Final Decision

Planning Commission

File number(s):	DR 22-05, EXCP 22-07, & VAR 22-06
Project name:	Woodburn Apartments
Date of decision:	November 10, 2022
Date of mailing:	November 14, 2022
Applicant:	Jim Toporek, Studio 3 Architecture
Landowner:	Woodburn Real Estate LLC
Site location:	119 N. Pacific Hwy (Tax Lot 051W17BC07500)

Site plan.

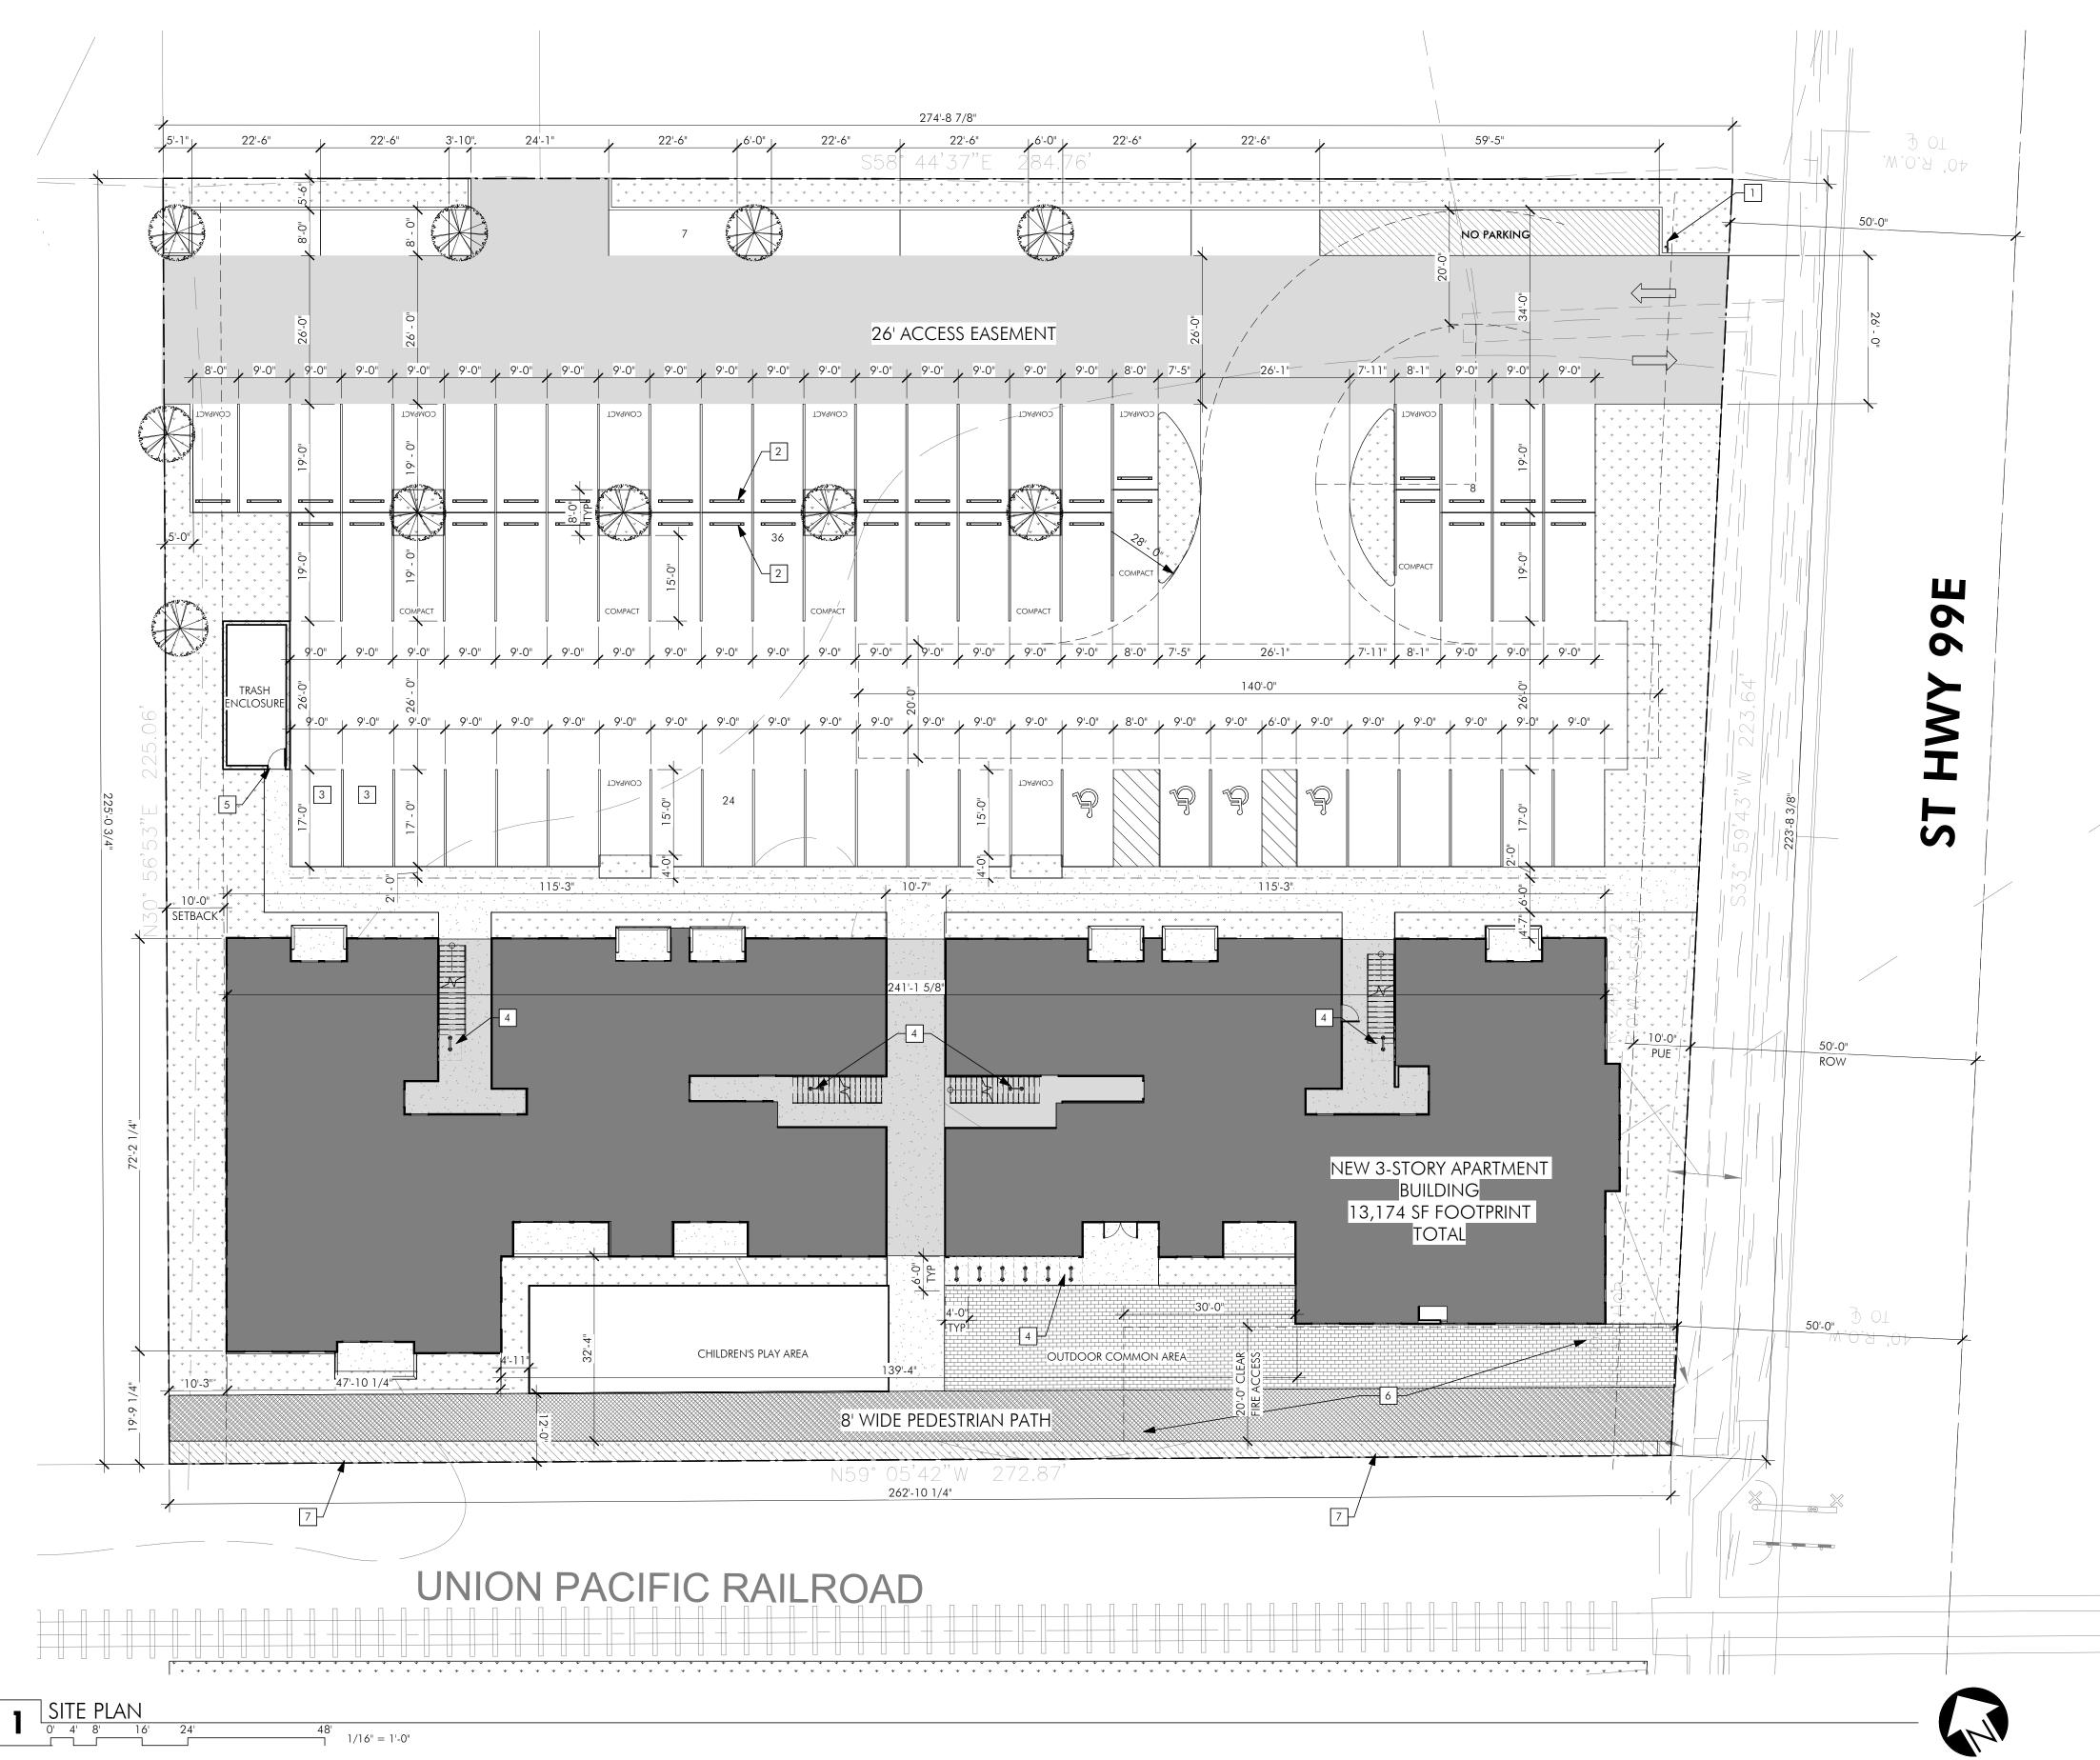
- b. Curb: Close the existing driveways and restore the existing curb line along the frontage, except as modified for the proposed driveways.
 - c. Sidewalk: Construct an 8-foot wide sidewalk along the frontage, with a 1-foot buffer between the sidewalk and the property line. The sidewalk shall connect into the existing sidewalk crossing the railroad in a manner acceptable to the Public Works Director and Oregon Department of Transportation. The sidewalk shall also connect to the proposed 8-foot path on site along the south property line.

- d. Landscape strip: Pursuant to WDO 3.06.03A3, the applicant shall revise the landscape plans to remove the six proposed street trees within the landscape strip area between sidewalk and curb. This area shall instead be planted at a ratio of 1 Plant Unit per 15 square feet, following the "Setbacks abutting a street" yard type within WDO Table 3.06A. Plant Unit values are outlined within Table 3.06B. Trees

are not allowed within this landscape strip. Provide a revised landscaping plan that demonstrates conformance.
